Access Compliance Report Public Rights-of-Way (Curb Ramps)

Main Street: ALLEGHENY_DR		Cross Street: KOOTENAY_DR		Location:	NE
ADA ID: RPAT211001102338	Ramp Type: Type 6 - Directional 1	Initial Pass/Fail: Fail	Overall Compliance: No	Severity Score:	20
Codes/Mitigation Info/Possible Solution			Field Measurements/Component Compliance

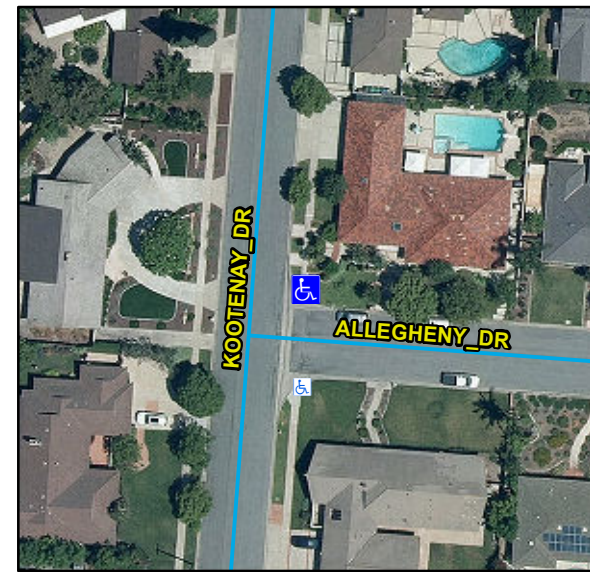
R304.5.1, R304.2.2, R304.5.3, STD 1115

Remove & Replace Entire Ramp.
